HIGHWAY WORK PROPOSAL

<u>COUNTY</u>	<u>STATE PROJECT</u>	<u>FEDERAL</u>	<u>PROJECT DESCRIPTION</u>	<u>HIGHWAY</u>
Milwaukee	1300-03-72	WISC 2021140	Lake Parkway - Milwaukee/St Francis; E Lincoln Ave To S Pennsylvania Ave	STH 794

ADDENDUM REQUIRED ATTACHED AT BACK

Addendum No. 04
ID 1300-03-72
Revised Sheet 383
February 3, 2021

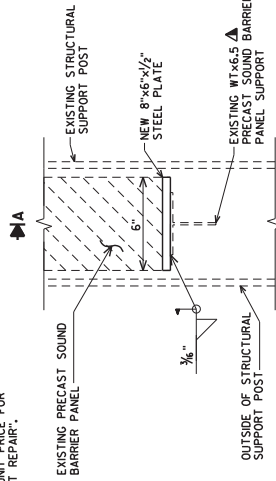
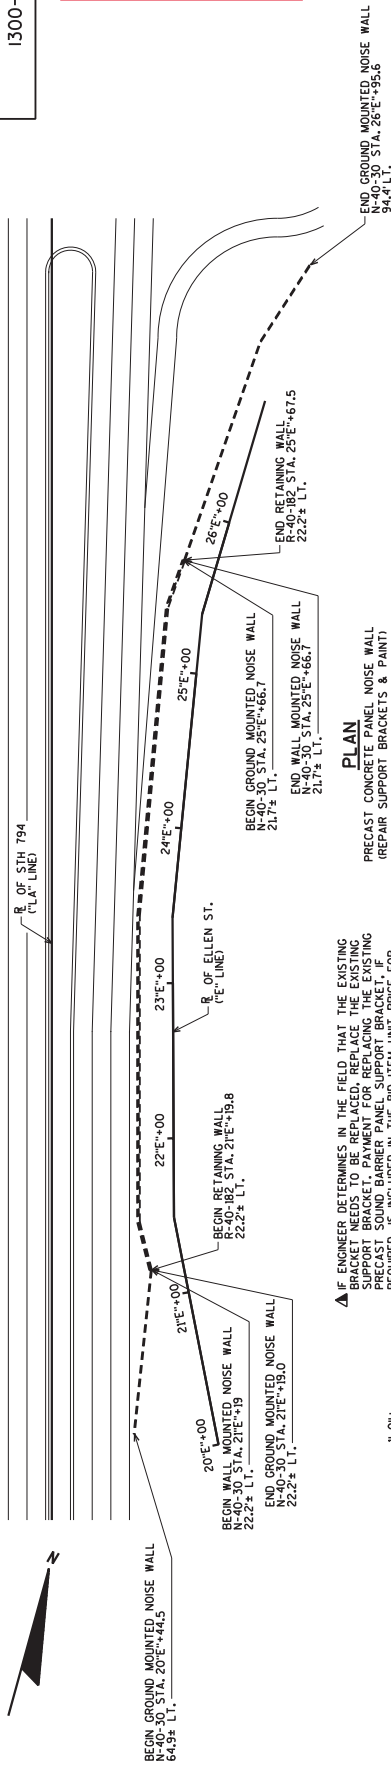
IF ENGINEER DETERMINES IN THE FIELD THAT THE EXISTING BRACKET IS TO BE REPLACED, THE CONTRACTOR SHALL BE RESPONSIBLE FOR REPAIRING THE EXISTING SUPPORT BRACKET. PAYMENT FOR REPLACING THE EXISTING PRECAST SOUND BARRIER PANEL SUPPORT BRACKET, IF REQUIRED, IS INCLUDED IN THE BID ITEM UNIT PRICE FOR "PRECAST SOUND BARRIER PANEL SUPPORT REPAIR".
